HISTORIC AND DESIGN REVIEW COMMISSION

August 05, 2015

HDRC CASE NO: 2015-307
ADDRESS: 268 W MARIPOSA
LEGAL DESCRIPTION: NCB 9013 BLK 7 LOT 11 12 AND 13
ZONING: R4 H
CITY COUNCIL DIST.: 1
DISTRICT: Olmos Park Terrace Historic District
APPLICANT: Jose Cueva
OWNER: Janet Vasquez
TYPE OF WORK: Demolish existing garage and construct small cottage
REQUEST:

The applicant is requesting final approval to:

PROPOSED SITE PLAN

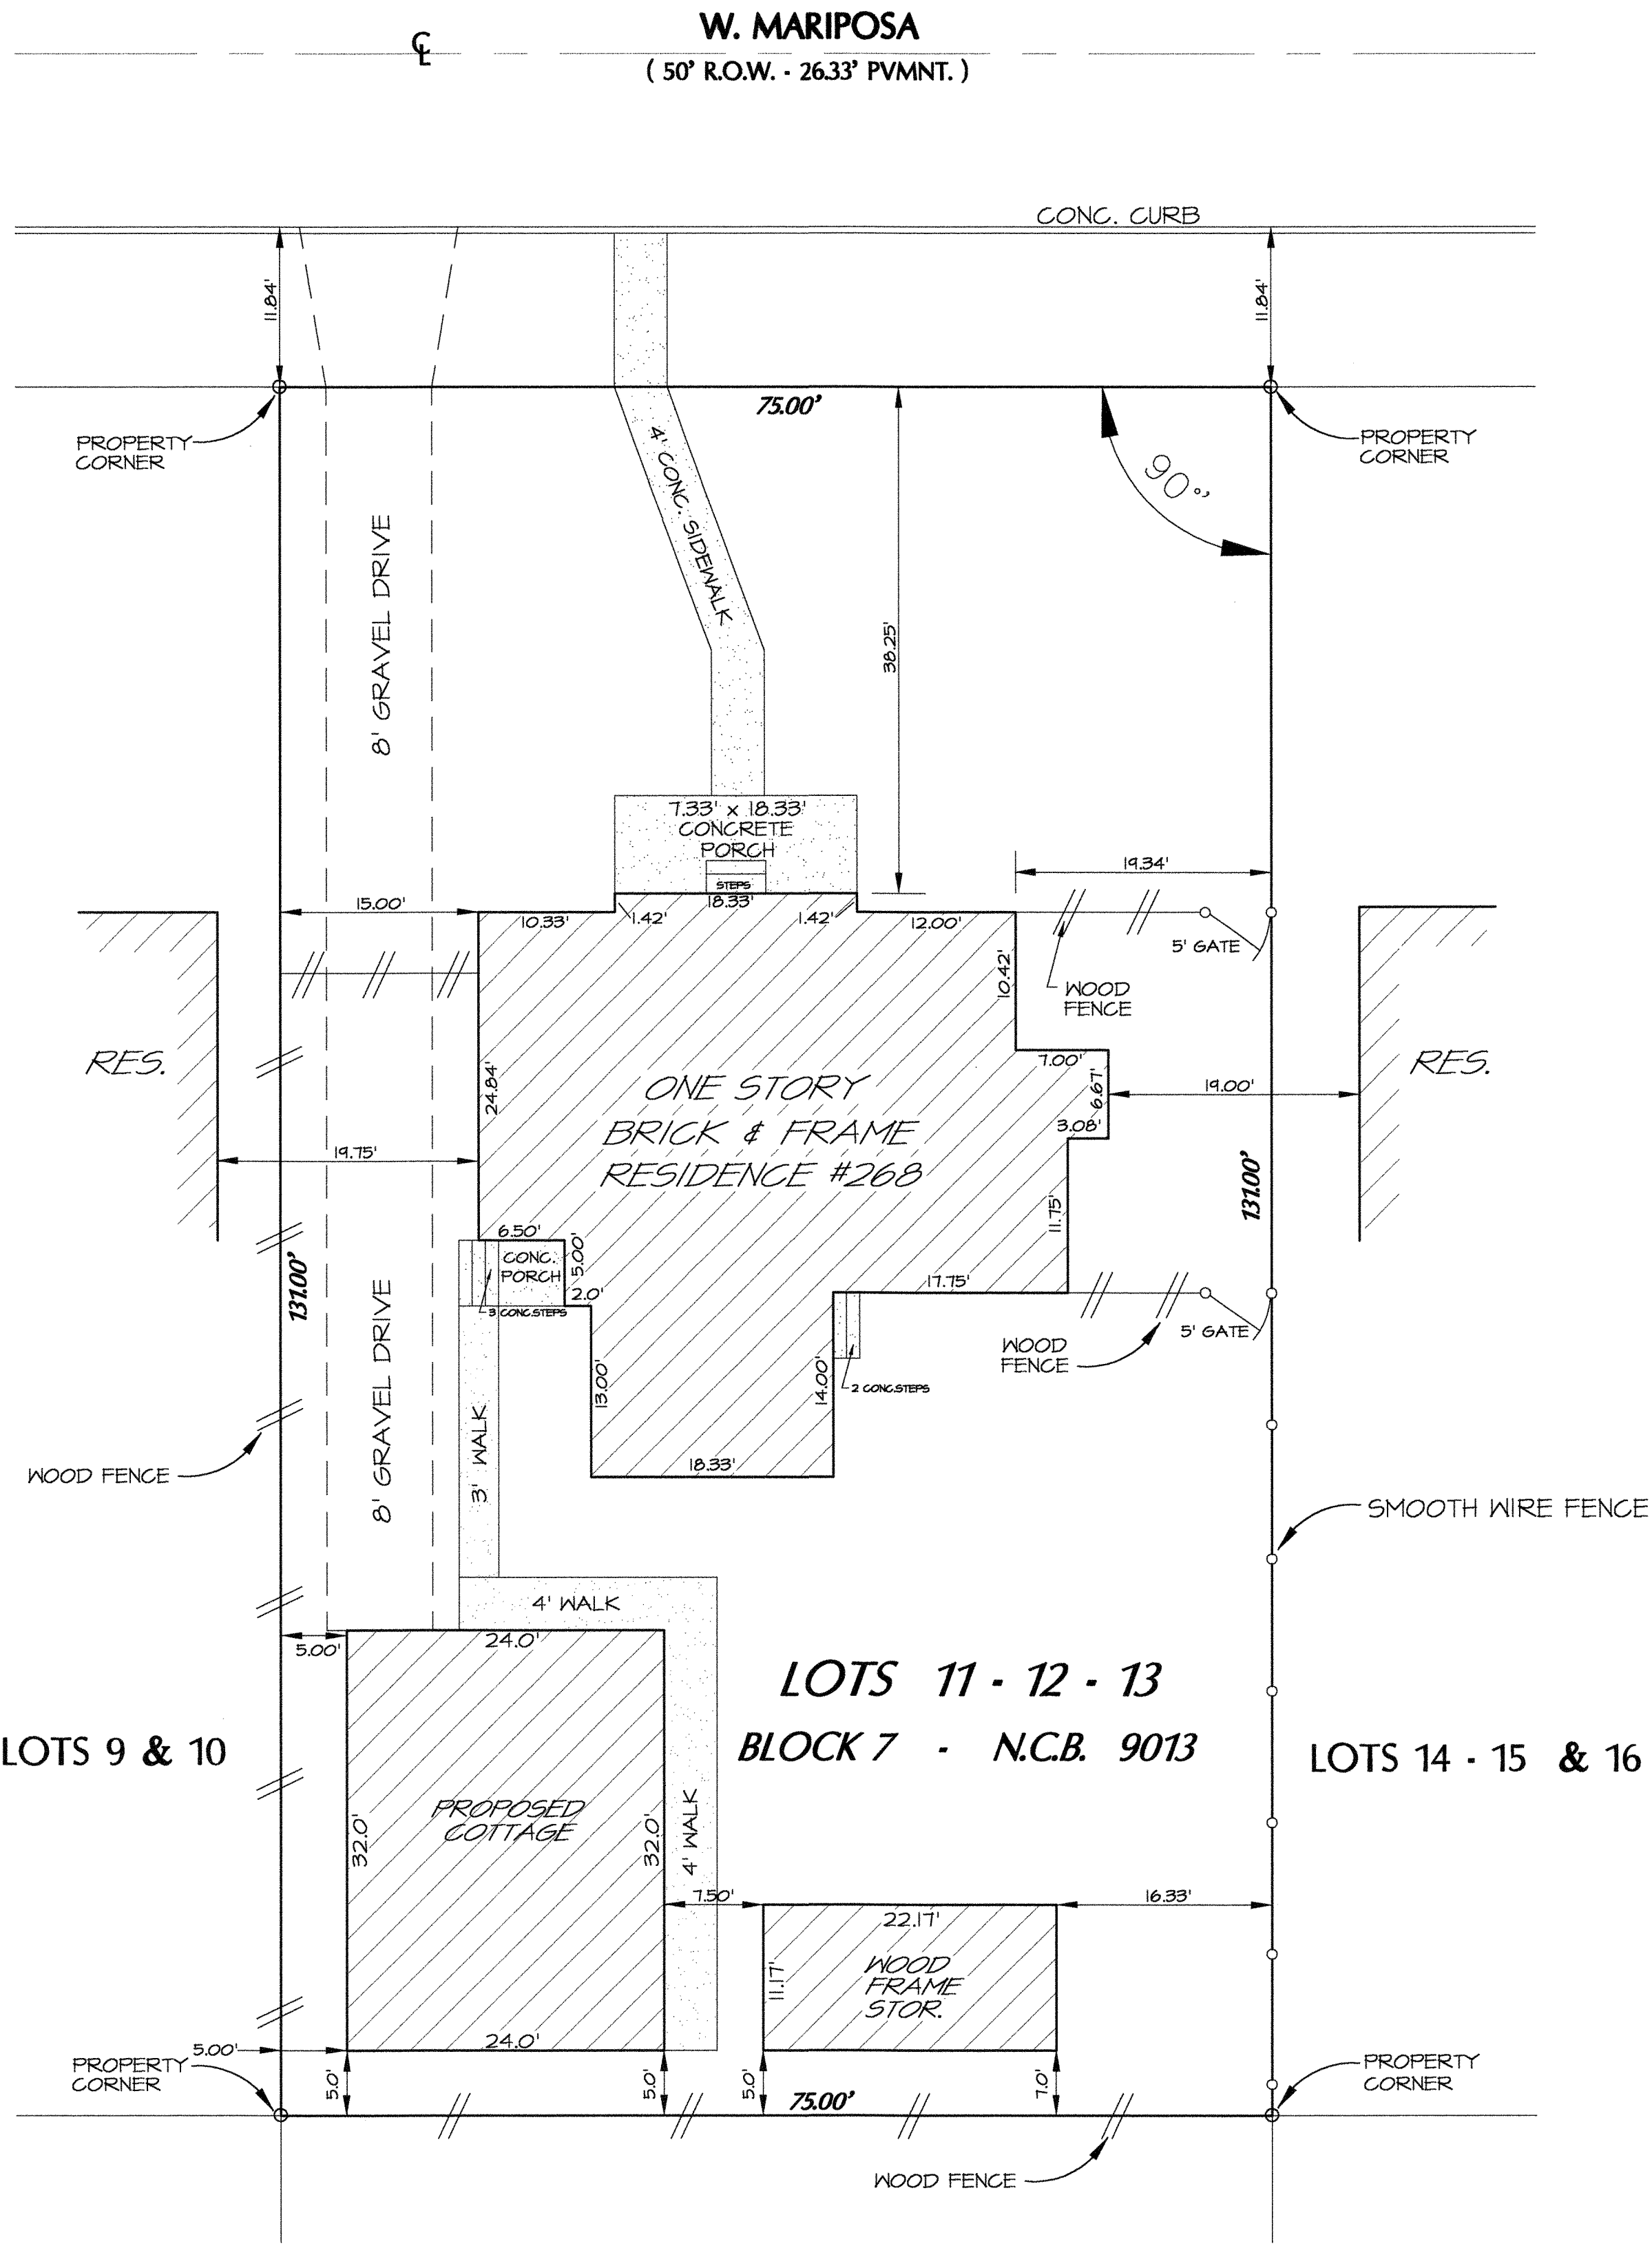
- g. According to the Guidelines for New Construction, historic setback patterns should be followed for new outbuildings. The proposed cottage will follow the side setback on the existing structure and expand the rear wall to meet the rear setback. The proposed setbacks are consistent with the guidelines. However, the new structure might encroach on the side setback which may require a variance.

EXTERIOR ELEVATIONS
268 W. MARIPOSA
SAN ANTONIO, TEXAS

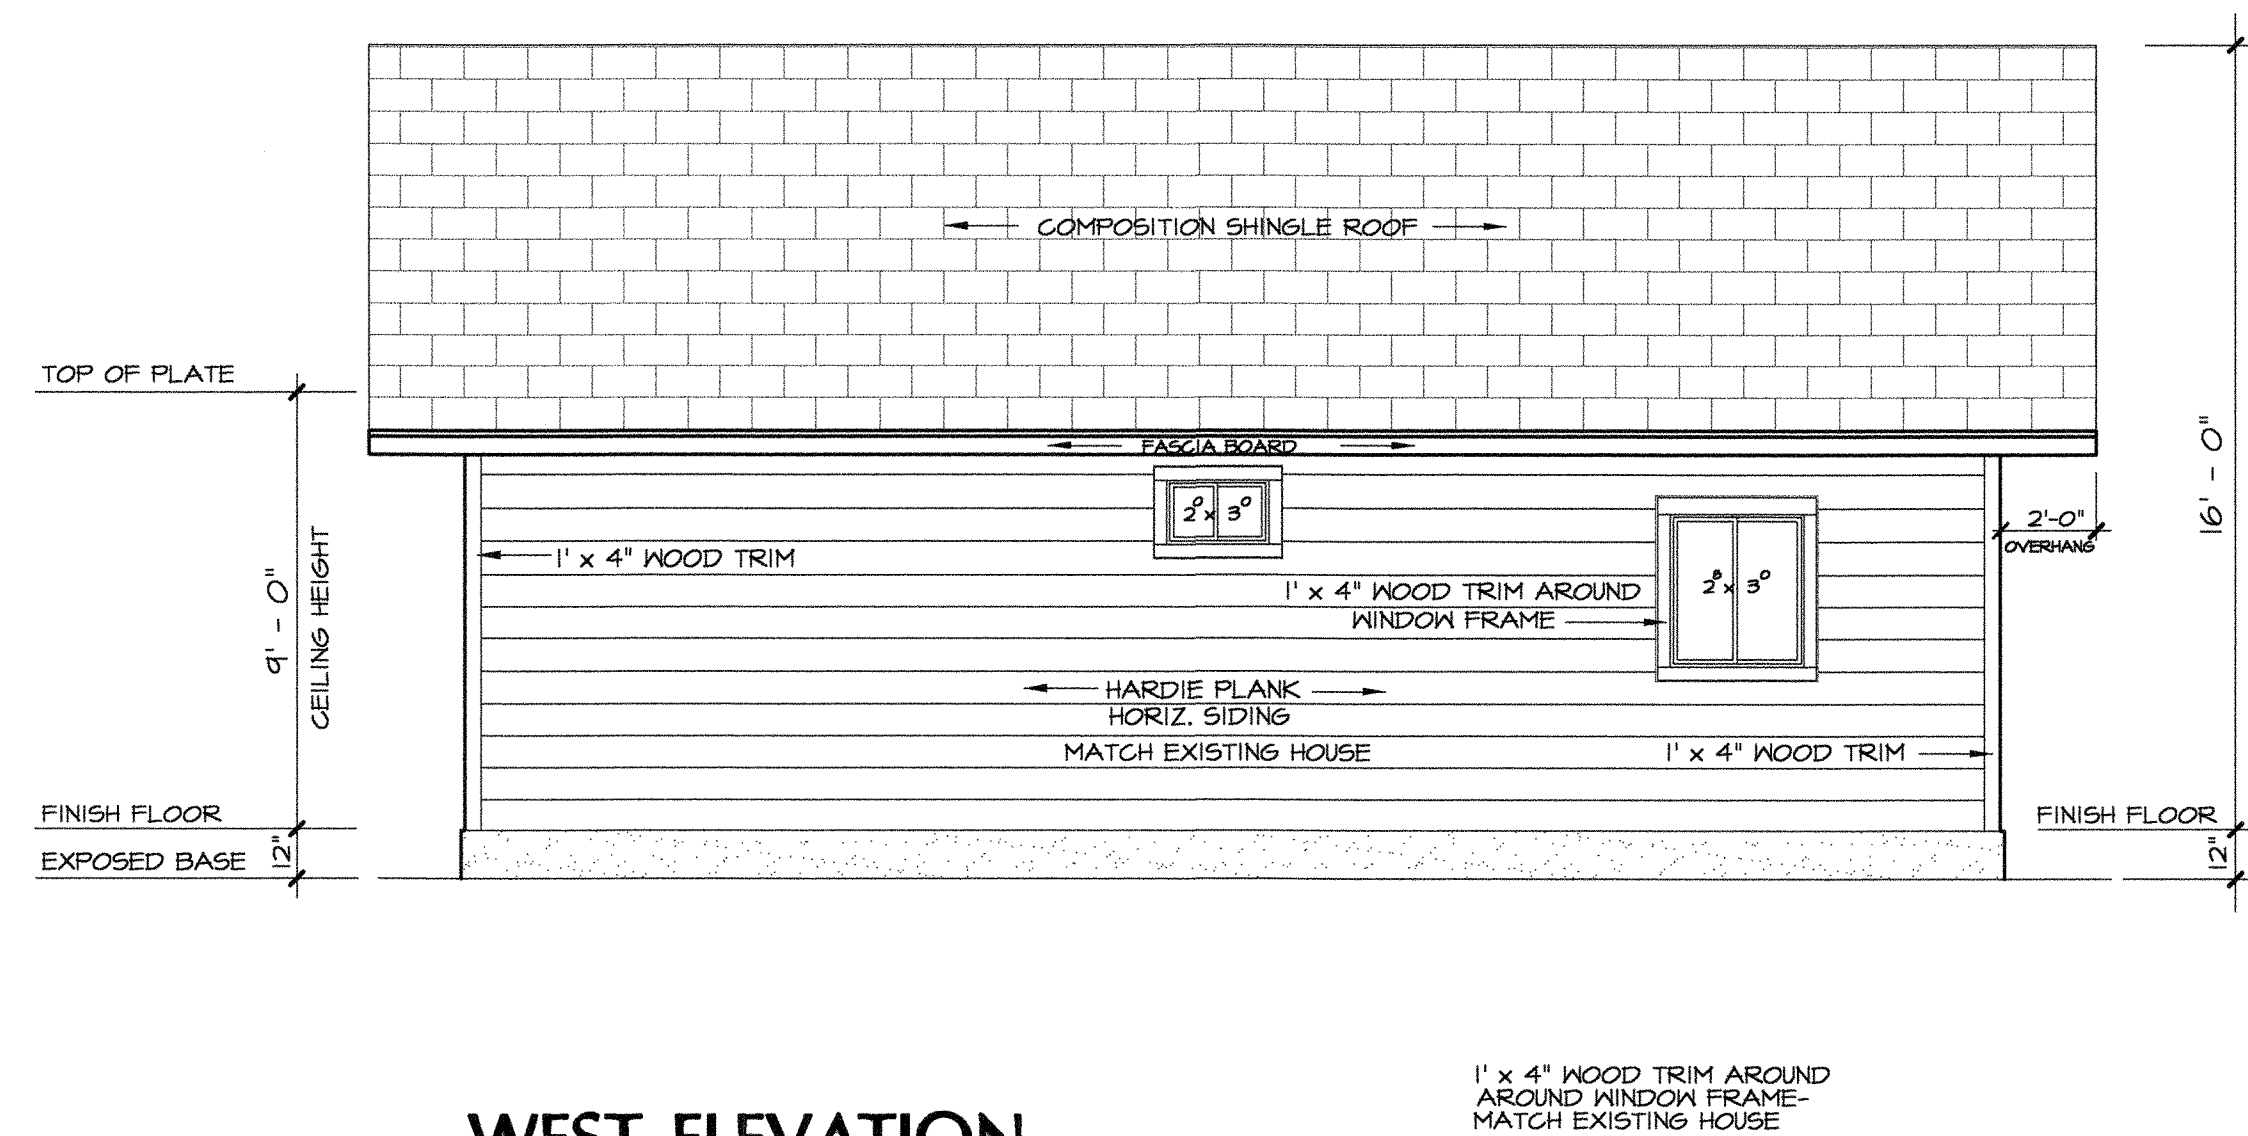
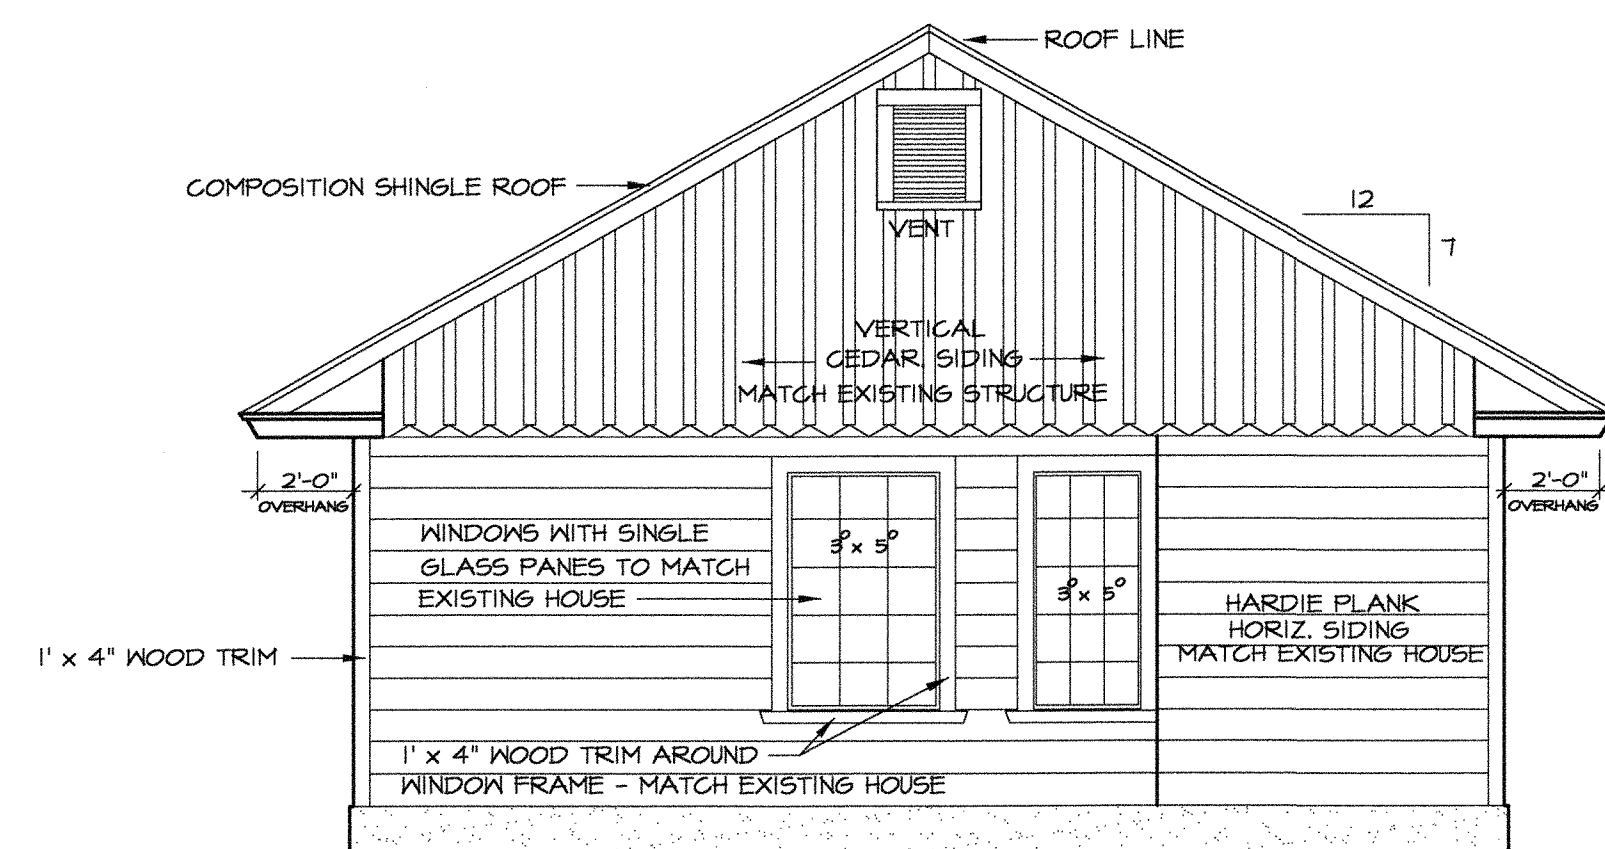
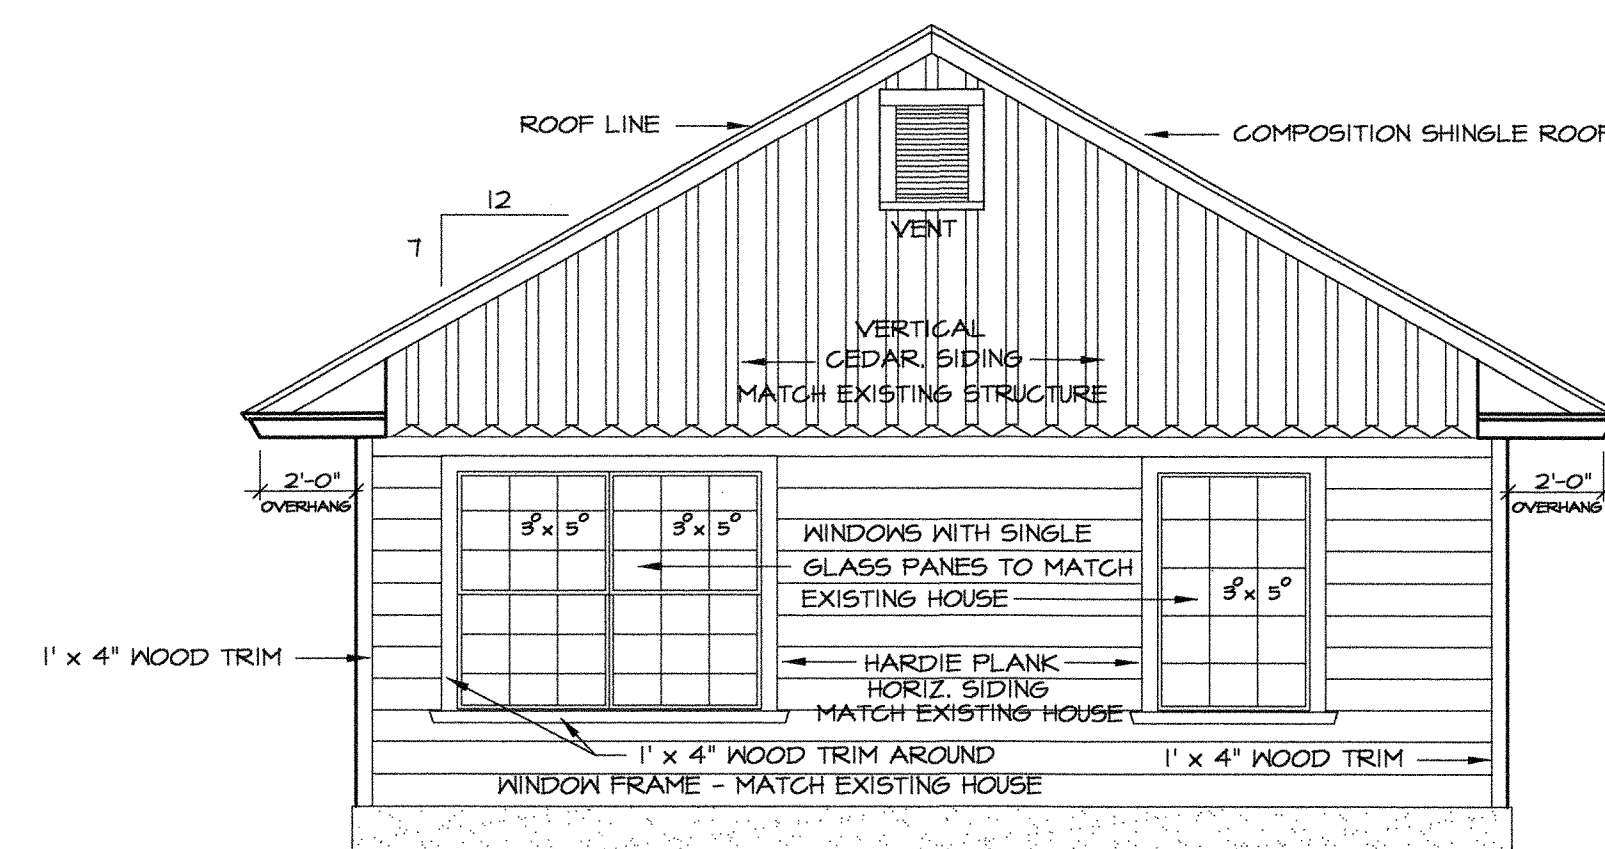
- h. The Guidelines for New Construction recommend new outbuildings to have window and door openings similar to those found on the principle structure in terms of spacing and proportions. The proposed windows do not feature similar proportions to the main house. The proposed windows have larger openings than what is found on the front façade of the primary structure. The proposed nine over nine aluminum windows will not match the six over six true divided lite windows on the house which should be avoided. In addition, the proposed doors are not of a typical door type that are traditionally found in historic districts and does not relate to the historic home. This is not consistent with the Guidelines for New Construction 5.A.iv.

- i. Vertical cedar siding will be added to the front of the gables. This will match the existing structure and would be an appropriate design detail. The applicant has proposed that all salvageable material saved from the dismantling of the existing garage will be used in the new construction.

Staff does not recommend approval based on finding h.
